Subject: Braidwood Station Unit 1  
NRC Docket Number 50-456

Response to Request for Additional Information Pertaining to Operating Interval  
Between Eddy Current Inspections for Circumferential Indications in the  
Braidwood Unit 1 Steam Generators

Figure 5.6

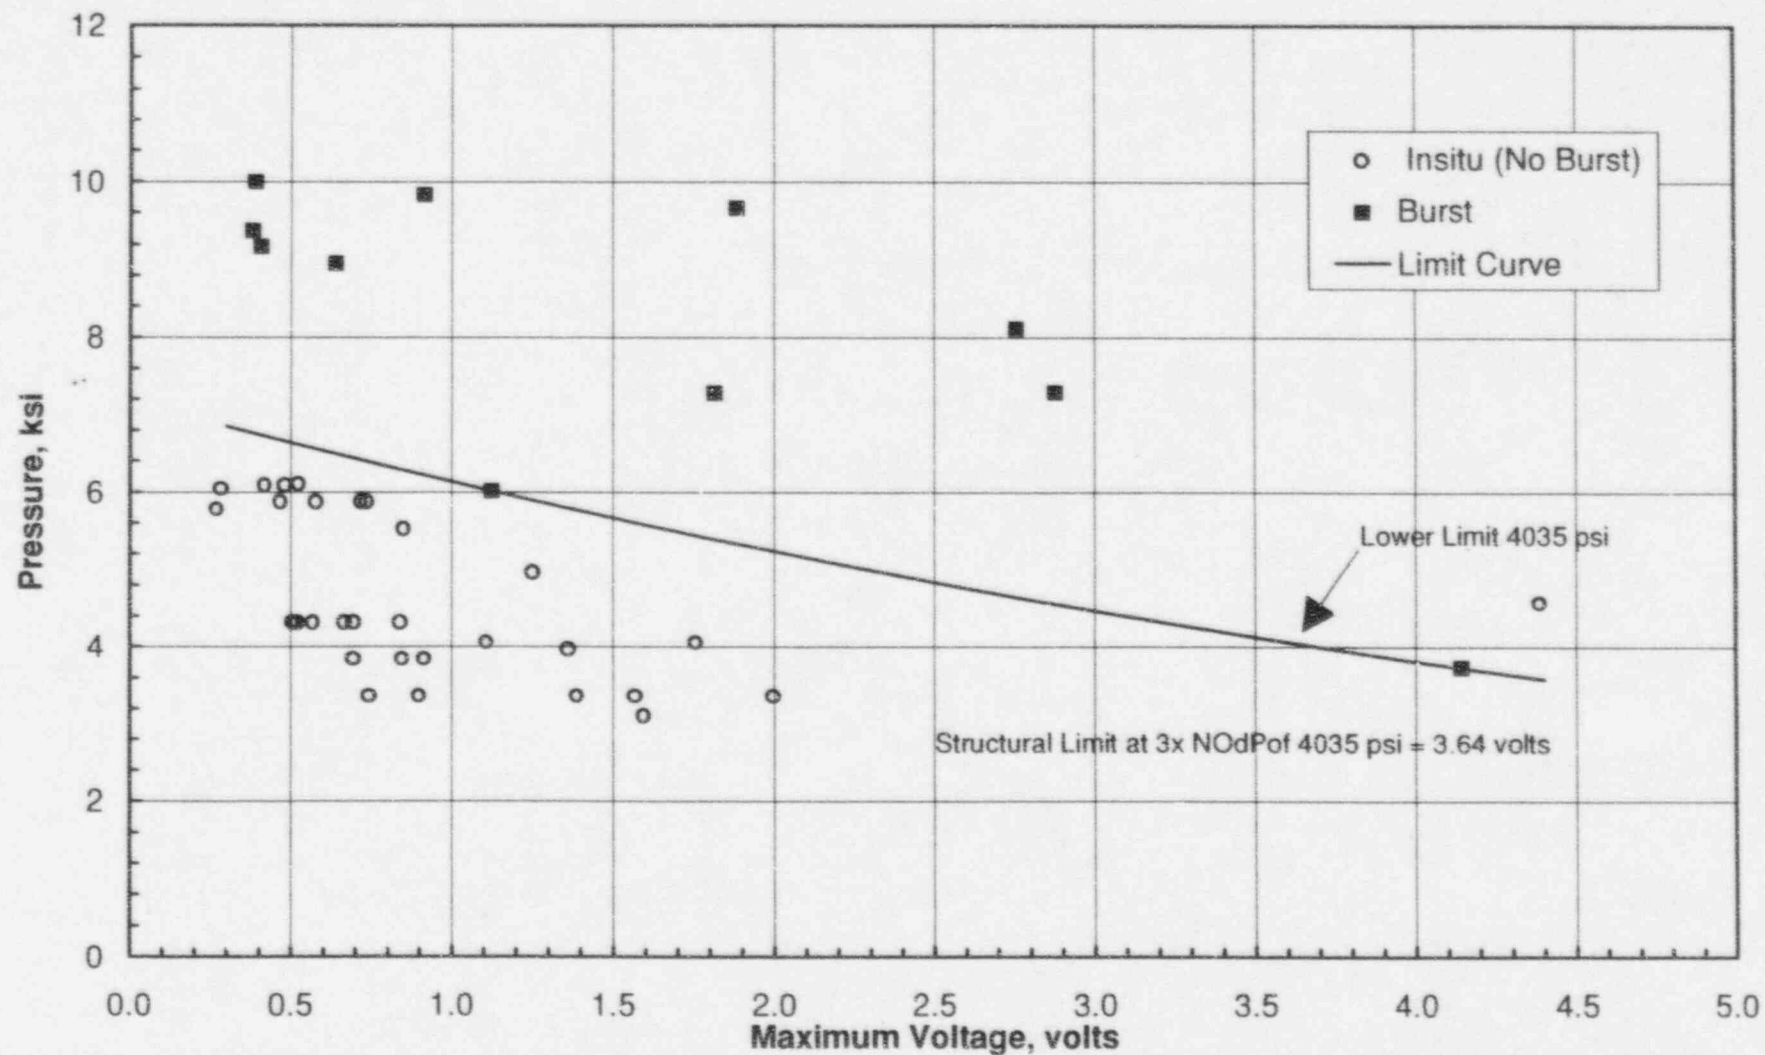
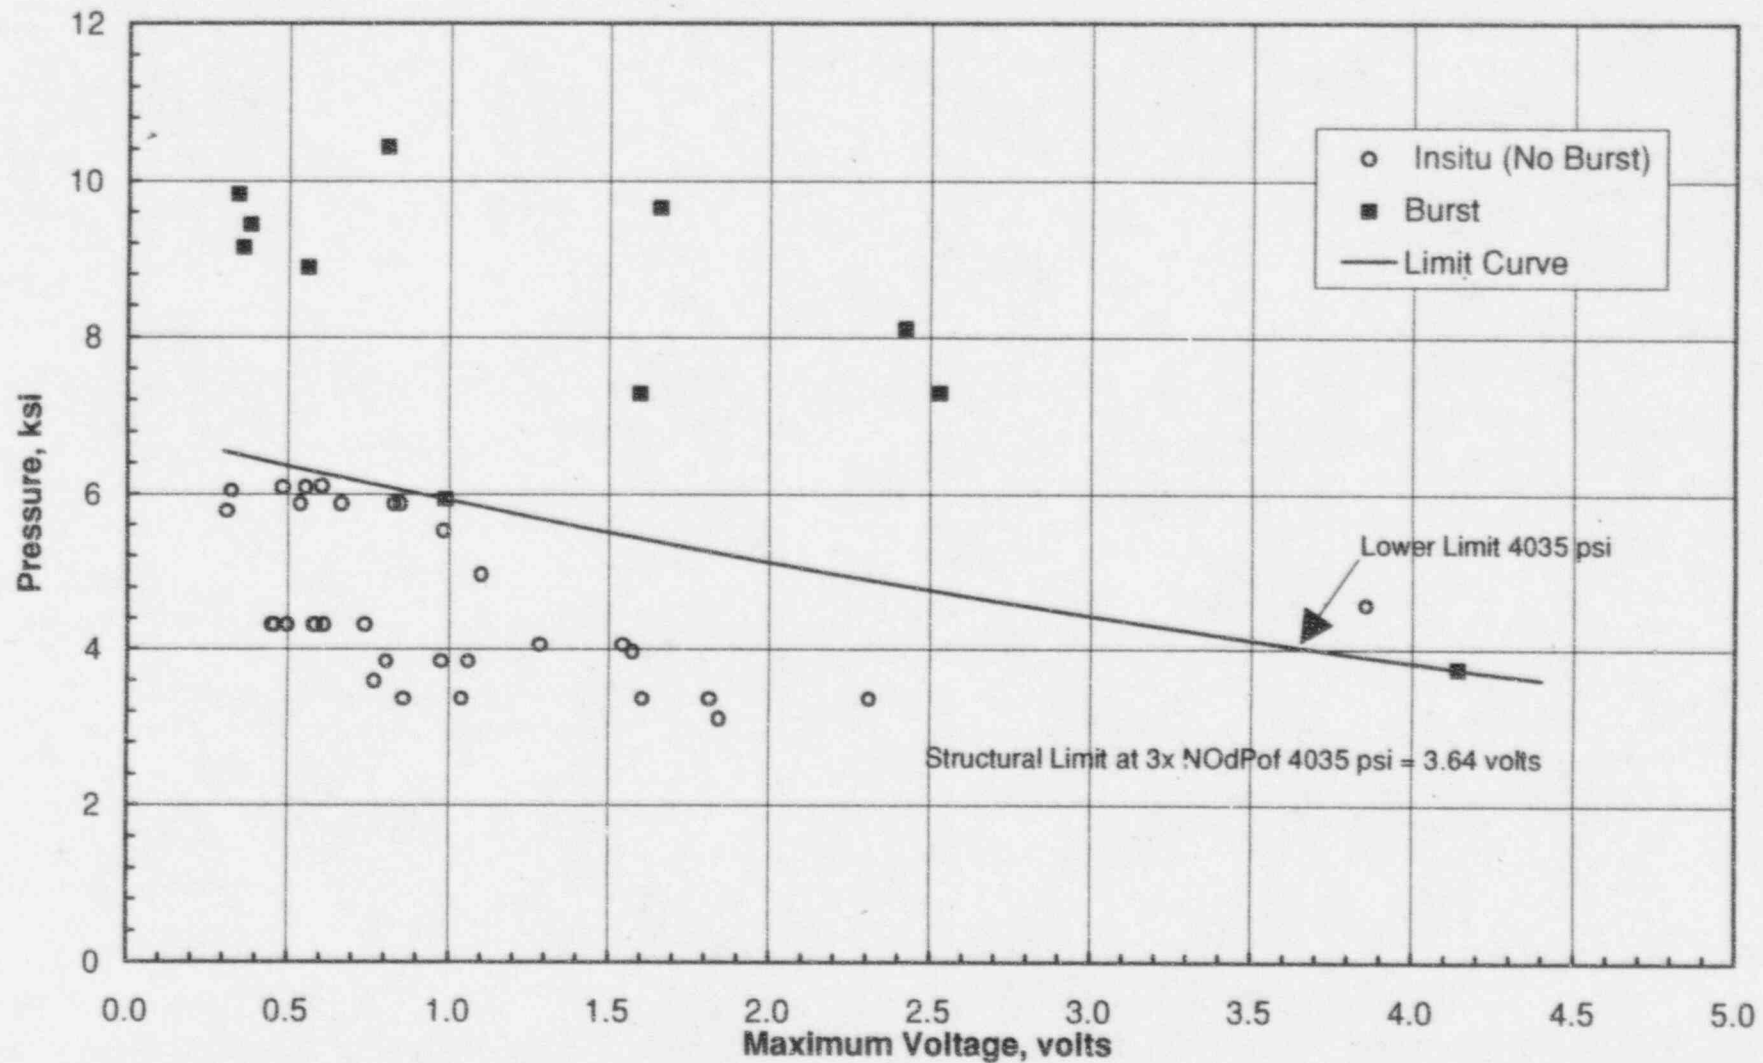
1. August 2, 1996, Submittal, Figure 5.5, 5.6 and 6.1 do not include one insitu pressure test point. Data for this test was acquired subsequent to the submittal and therefore it was not included in the figures. The point is located at 0.67 max Volts and 0.28 avg. Volts corresponding to a corrected test pressure of 3.577 ksi.

This additional point has been included in all analyses. The additional data point does not change the results or conclusions of the report. Additionally, the axes on Figure 6.1 were incorrectly labeled in the August 2, 1996 submittal. The updated Figures 5.5, 5.6 and 6.1 are attached.

Figure 7.1

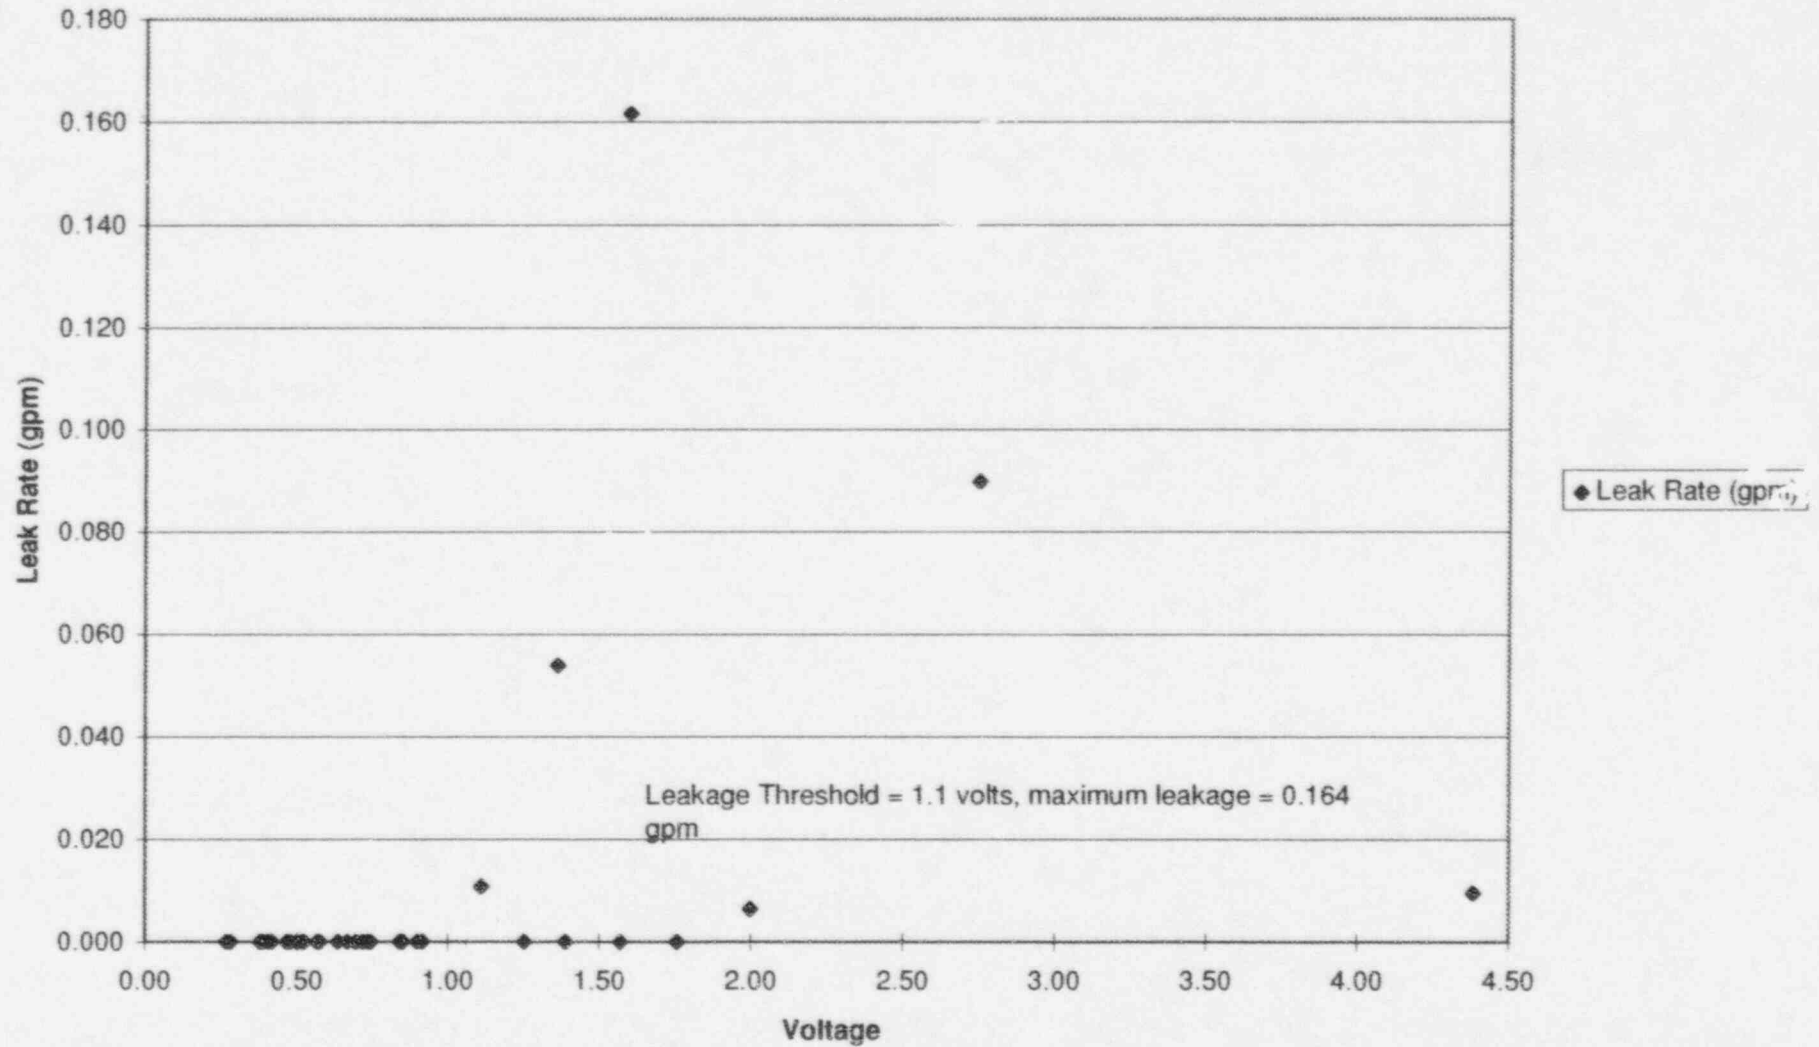
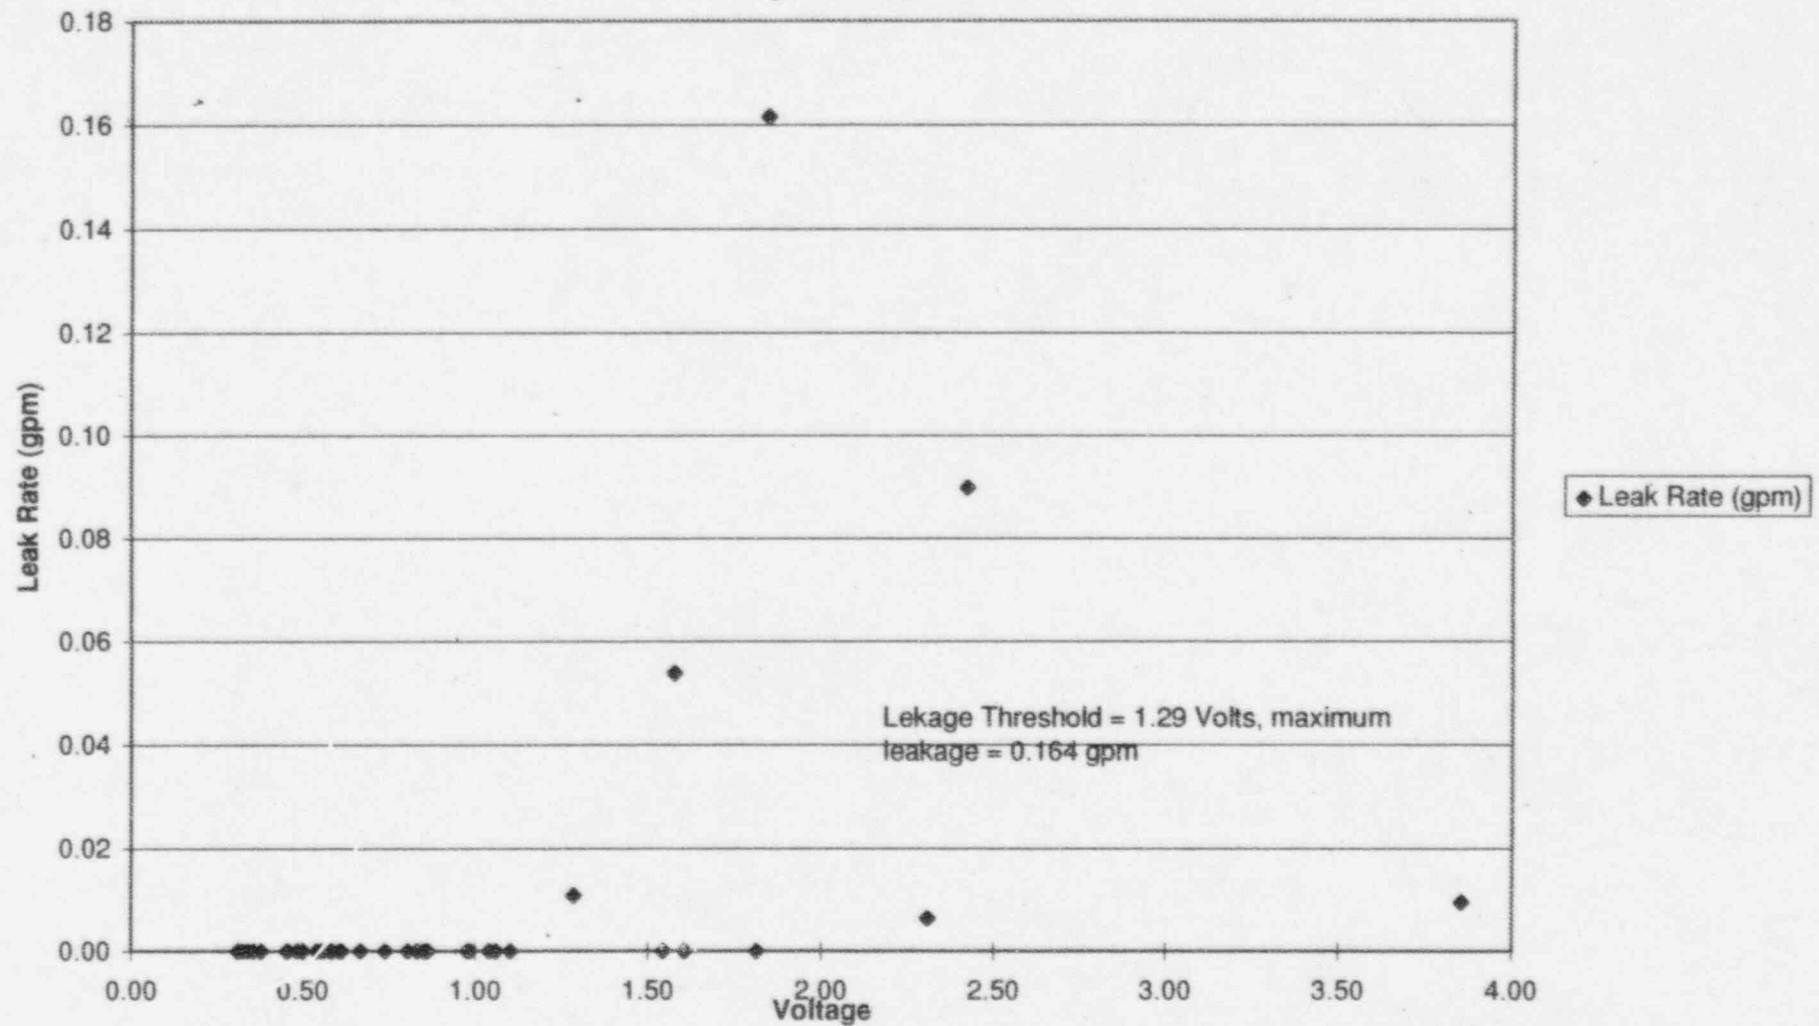
2. The leak rate of one of the data points in the August 2, 1996, submittal Figure 7.1 and Figure 14a in the September 10, 1996, submittal had an incorrect leak rate. The leak rate was previously presented on these figures as 0.00352 gpm. This leak rate was incorrectly calculated for the maximum pressure instead of the leak test pressure. The correct leak rate is 0.0064 gpm. Because a bounding leak rate is assumed for the EOC distribution this change has no effects on the report conclusions or the EOC predicted leak rate.

Figure 10a

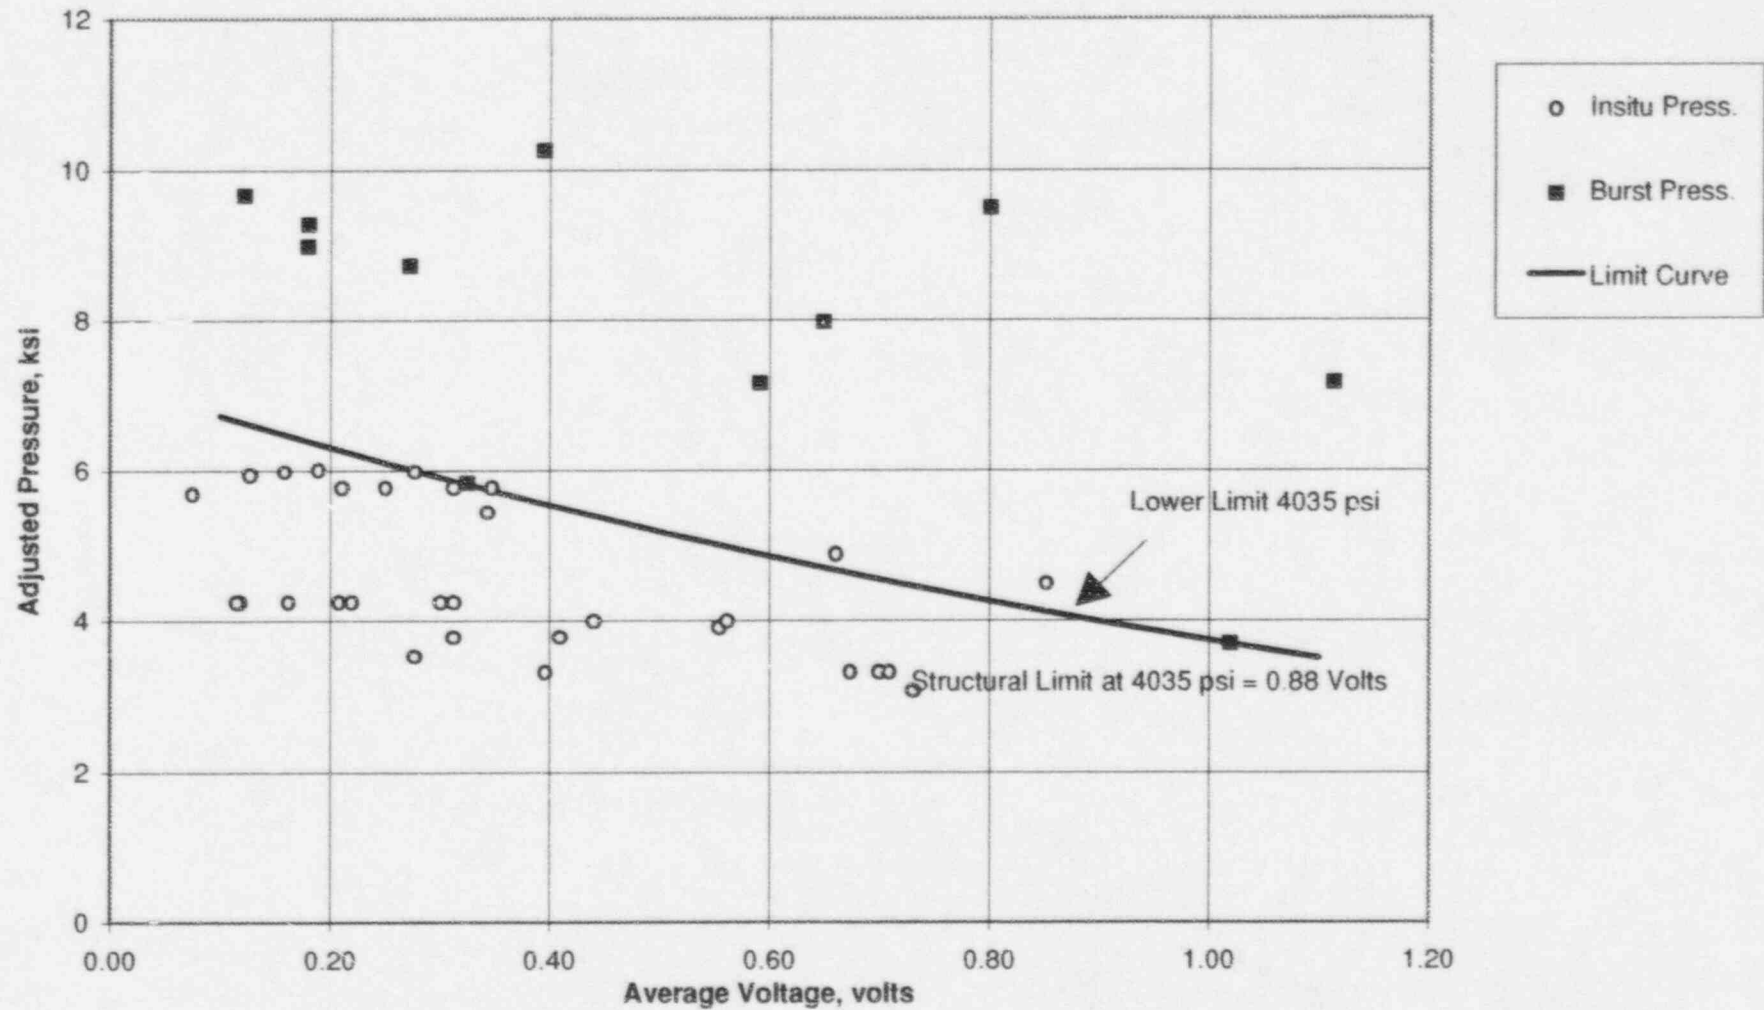
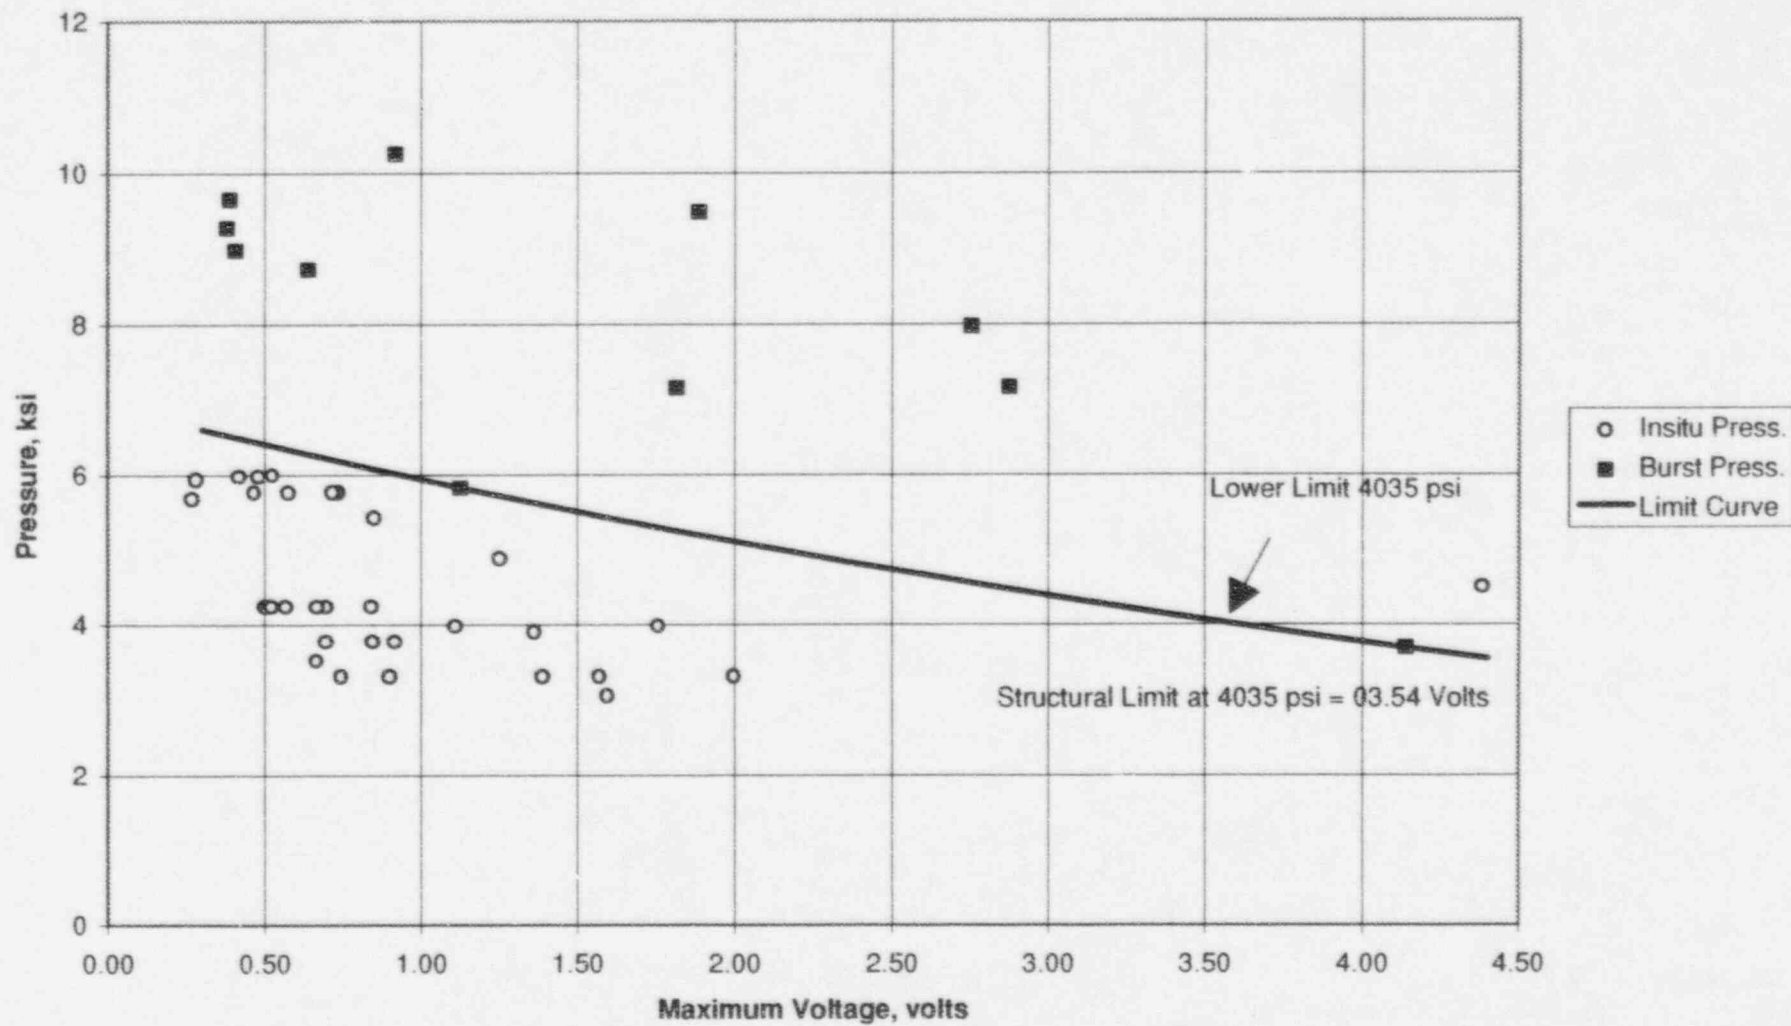
3. Incorrect voltages for one insitu pressure test point were presented on Figures 10a and 10b of the September 10, 1996, submittal. The voltages presented were 0.88 max and 0.63 average volts at a corrected pressure of 3.577 ksi. The voltage data were originally analyzed as 0.080" RPC and no correction applied. Further review of the data identified that the data was acquired with the 0.115" RPC and a correction factor was applied. This data point does not change the results or conclusions of the submittal.
